**UNIVERSITY OF NEW MEXICO HOSPITALS - NEW HOSPITAL TOWER
ARCHITECT'S SUPPLEMENTAL INSTRUCTIONS (ASI)**

Bid Package: Phase I - Make Ready
ASI #: 06

No	Doc Ref	Revision description
CIVIL		
1	CABQ Project 631783 (4 sheets)	City Approved work order for signing, striping, and signalling @ Univeristy Blvd. & Tucker Ave. (Work as described in the attached 4 sheets)

UNMH MODERN MEDICAL FACILITY
PERMANENT SIGNING AND STRIPING
UNIVERSITY AVE @ TUCKER AVE NE

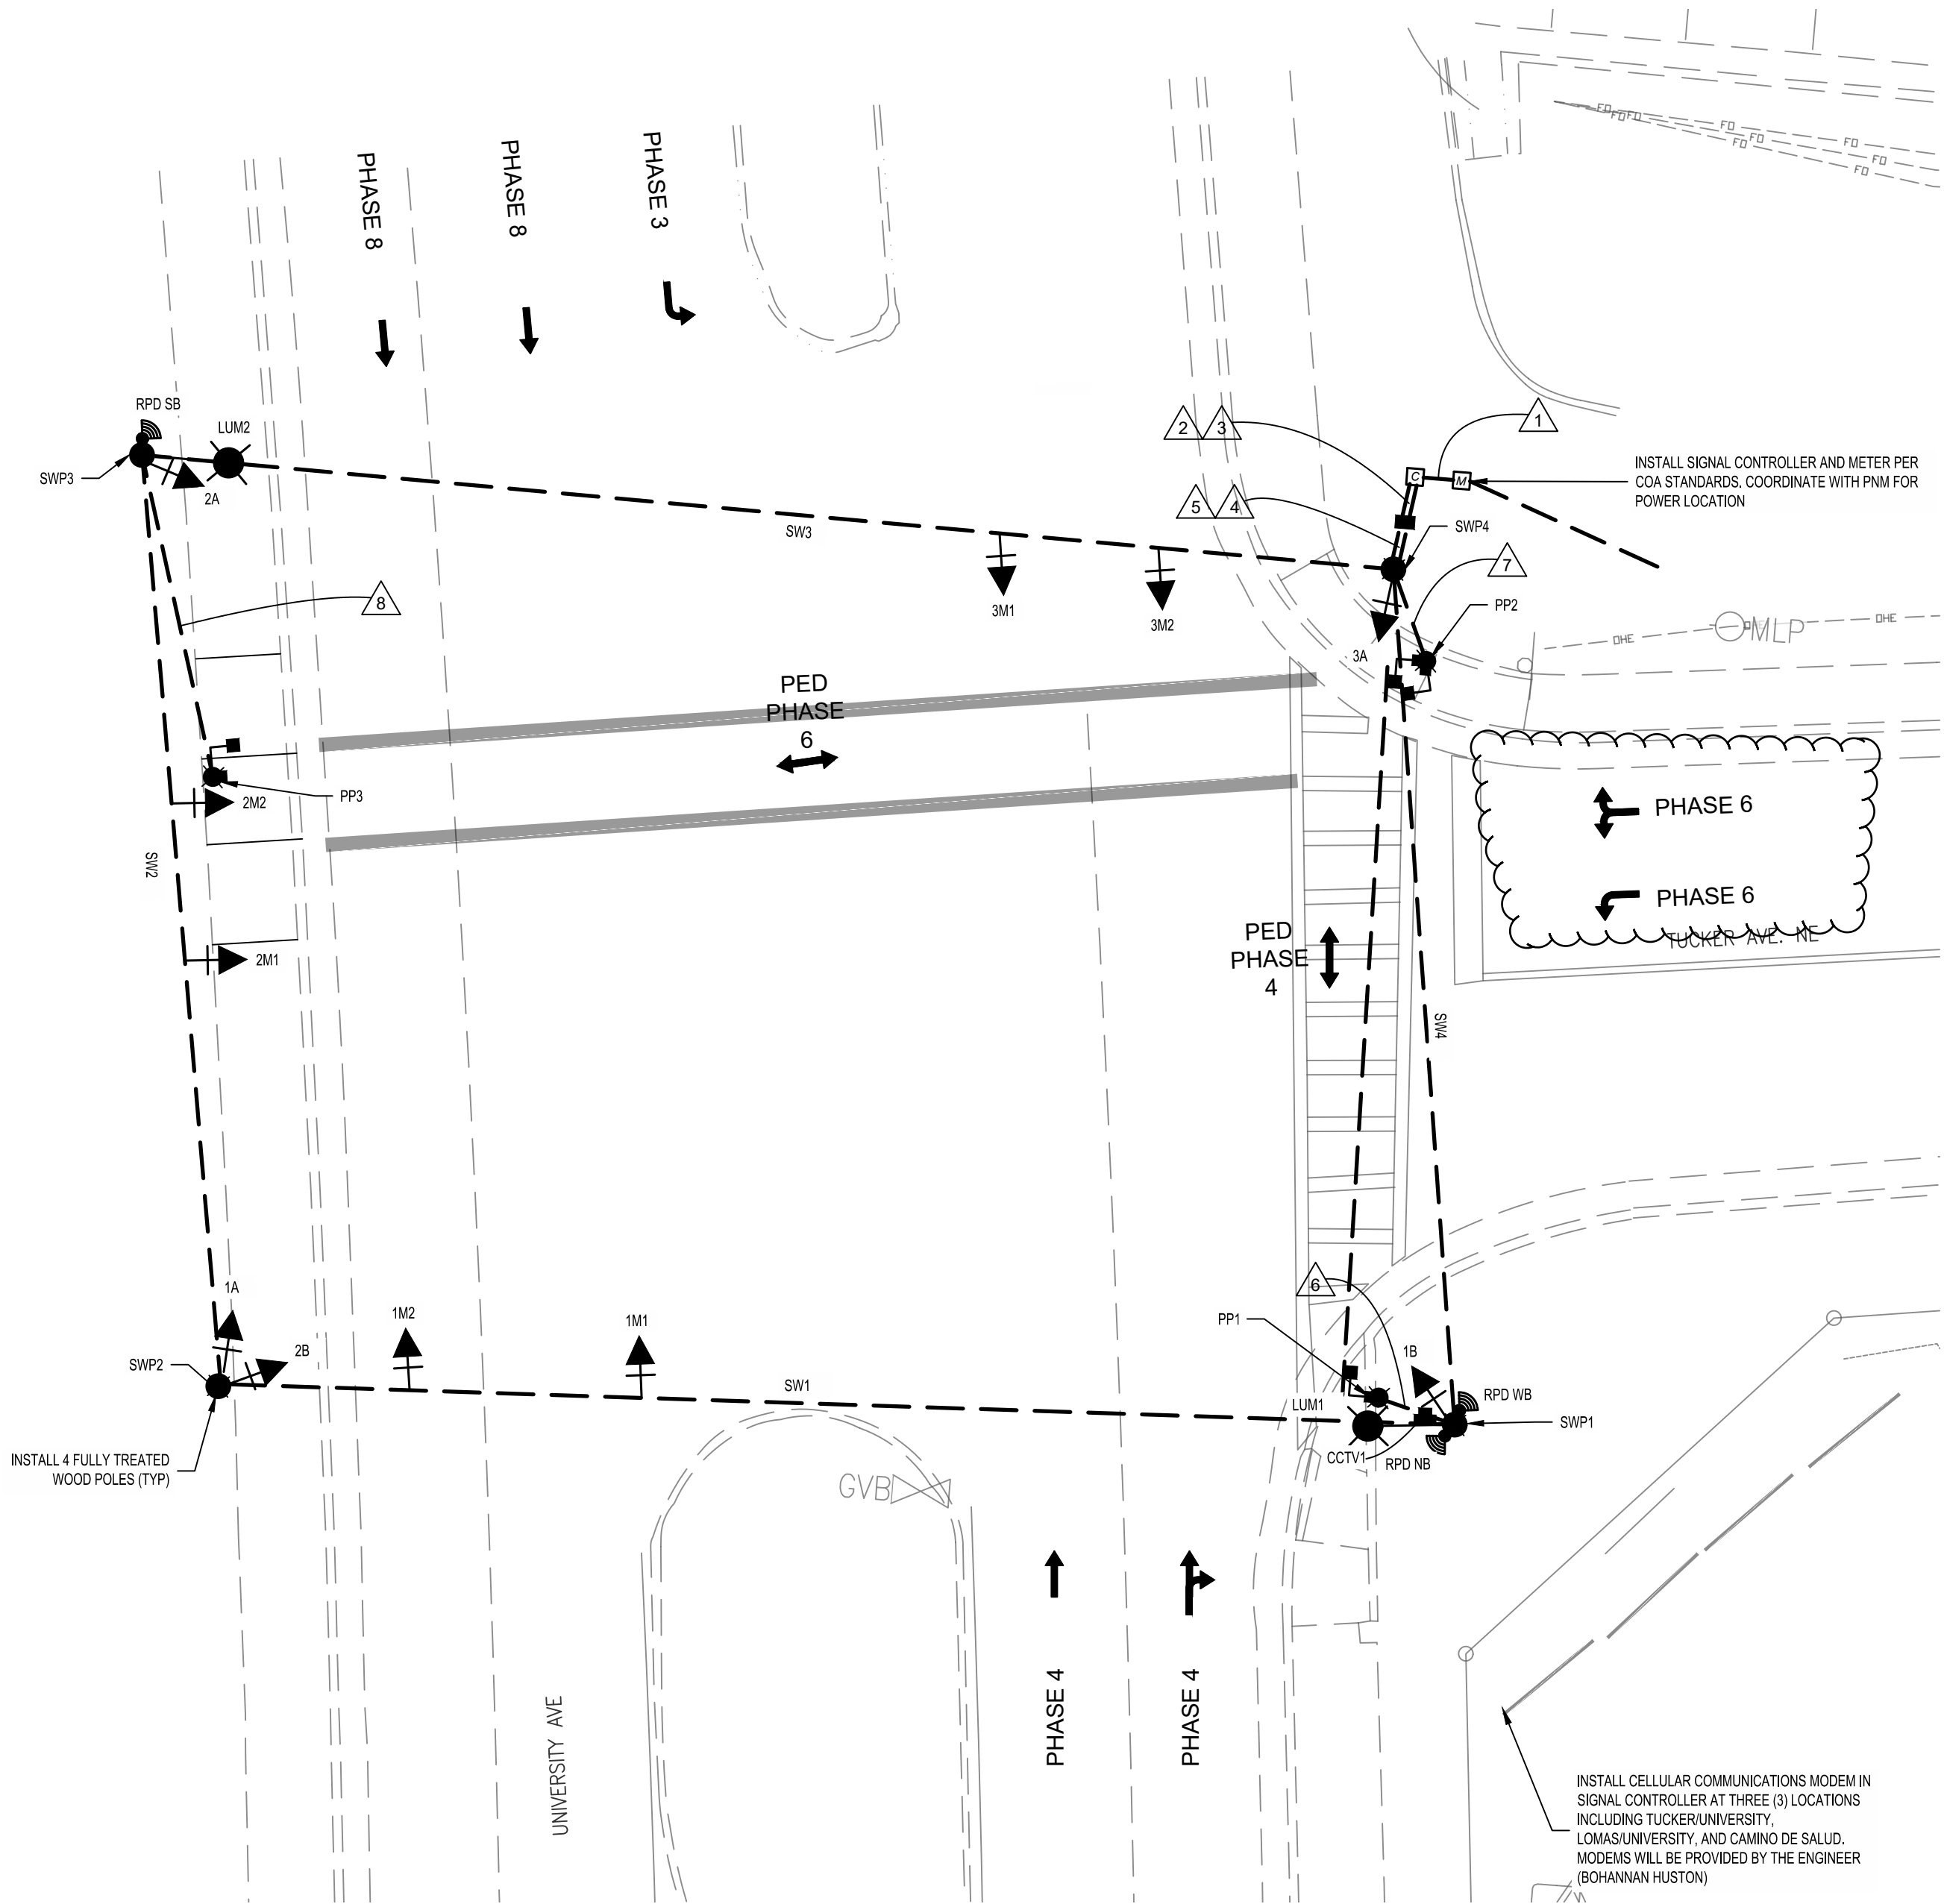
1. REMOVE AND SALVAGE EXISTING STOP SIGN. REINSTALL WHEN THE TEMPORARY SIGNAL IS REMOVED
2. REMOVE PAVEMENT MARKINGS.
3. INSTALL REFLECTORIZED PAINTED 4" SOLID WHITE STRIPE

4. INSTALL REFLECTORIZED PAINTED 4" DOUBLE YELLOW STRIPE
5. INSTALL RELECTORIZED PAINTED WHITE 24" SOLID WHITE STRIPE (FOR STOP BARS)
6. PAINTED MEDIAN NOSE - REFLECTORIZED YELLOW PAINT. PAINT 6' BACK FROM PC/PT

7. DID NOT USE
8. DID NOT USE
9. DID NOT USE
10. INSTALL RELECTORIZED PAINTED WHITE 24" SOLID WHITE STRIPE (FOR CROSSWALK)
11. EXISTING PAVEMENT MARKINGS TO REMAIN

12. EXTENT OF STRIPING REMOVALS. MATCH EXISTING
13. DID NOT USE
14. DID NOT USE
15. INSTALL NEW ADA PEDESTRIAN RAMP PER COA STANDARD DRAWING 2443 DETAIL A - PARALLEL CURB RAMP.

16. REMOVE ADA RAMP AND INSTALL AT GRADE SIDEWALK WHEN TEMPORARY SIGNAL IS REMOVED.
17. REMOVE CROSSWALK STRIPING WHEN TEMPORARY SIGNAL IS REMOVED. RAMP AND CROSSWALK TO REMAIN FOR THE DURATION OF THE TEMPORARY SIGNAL.

18. EXISTING FIRE HYDRANT TO REMAIN PROTECTED IN PLACE.

1. ALL PAVEMENT STRIPING SHALL BE RESTORED TO EXISTING CONDITIONS WHEN TEMPORARY SIGNAL IS REMOVED
